Access Compliance Report

Public Rights-of-Way

(Curb Ramps)

Intersection ID: 23444	Main Street: TRAVELERS_CT	Cross Street: PROVIDENCE_LN_WEST	Location: S
ADA ID: 87A50FCD9AF5	Ramp Type: BlendTrans2	Initial Pass/Fail: Fail	Overall Compliance: No
Severity Score: 8.75			
Codes/Mitigation Info/Possible Solution		Field Measurements/Component Compliance

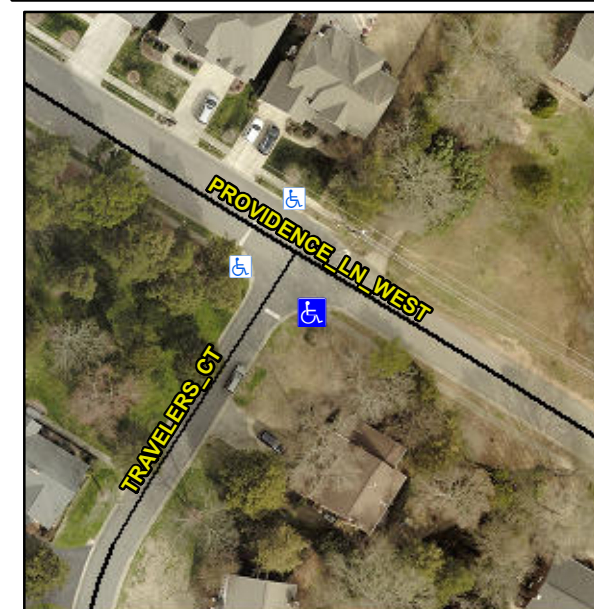
Not Found, R304.5.1

Compliance	Description	Data	Compliance	Description	Data
N/A	Ramp Length (in)	68.0	Yes	BlendTrans Slope (%)	2.5
No	Ramp Width (in)	47.0	Yes	BlendTrans XSlope (%)	0.3
N/A	Flare Type LT	N/A	N/A	Flare Type RT	N/A
N/A	Flare Slope LT (%)	N/A	N/A	Flare Slope RT (%)	N/A
N/A	Flare Traversable LT?	N/A	N/A	Flare Traversable RT?	N/A
N/A	Landing Length (in)	N/A	N/A	DWS Provided?	N/A
N/A	Landing Width (in)	N/A	N/A	DWS Contrast?	N/A
N/A	Landing Slope (%)	N/A	N/A	DWS Length (in)	N/A
N/A	Landing X Slope (%)	N/A	N/A	DWS Full Width?	N/A
N/A	Landing Curb? (Y/N)	N/A	N/A	DWS Offset (in)	N/A
N/A	Shared Landing?	N/A			
N/A	Gutter Ponding?	N/A	N/A	Gutter Slope (%)	N/A
N/A	Gutter Lip Ht (in)	N/A	N/A	Gutter X Slope (%)	N/A
N/A	Painted X Walk1?	No	N/A	Painted X Walk2?	No
	X Walk 1 Direction	To NE		X Walk 2 Direction	To NW
	X Walk 1 Width (in)	N/A		X Walk 2 Width (in)	N/A
	X Walk 1 Slope (%)	3.6		X Walk 2 Slope (%)	4.3
	X Walk 1 X Slope (%)	2.3		X Walk 2 X Slope (%)	4.9

N/A	Ramp inside XWalk1?	N/A	N/A	Ramp inside XWalk2?	N/A
	Road Slope (%)	3.2		Clear Space?	N/A
	Road X Slope (%)	5.8	N/A	Clear Space to XWalk (in)	N/A
N/A	Any Obstructions?	N/A	N/A	Storm Grate/Utility Hazard?	N/A
	Obstruction Type			Storm Grate/Utility Type	
		N/A			N/A
			Yes	Surface Condition? (G/P)	Good
			No	Curb Slope (%)	28.2

Remove & Replace Curb Ramp With Two New Directional Ramps or Equivalent.
